Pressura eSTAR Readiness Review

Comprehensive report

PTC-200 | Expanded fictional case ESTAR-TC-005B | Revision 3 | October 14 2026

Not ready for submission based on the expanded fictional evidence package.

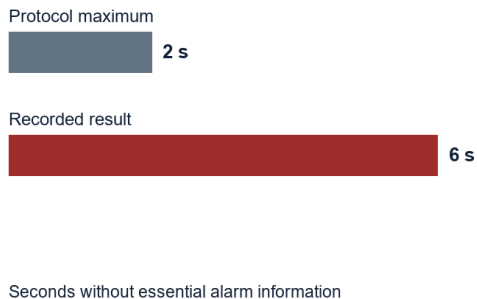
XL regulation fails the lower limit

Timer meets the accuracy limit

Alarm interruption exceeds the limit

Battery task needs independent success

Figure 1. Numeric observations from D07, D08 and D09. The XL results and alarm information interruption exceed their stated criteria. The timer meets its limit, so its finding concerns the summary calculation. Three assisted battery task completions require human factors adjudication. All data are authored fiction; the figure adds no tested configurations or inferred measurements.
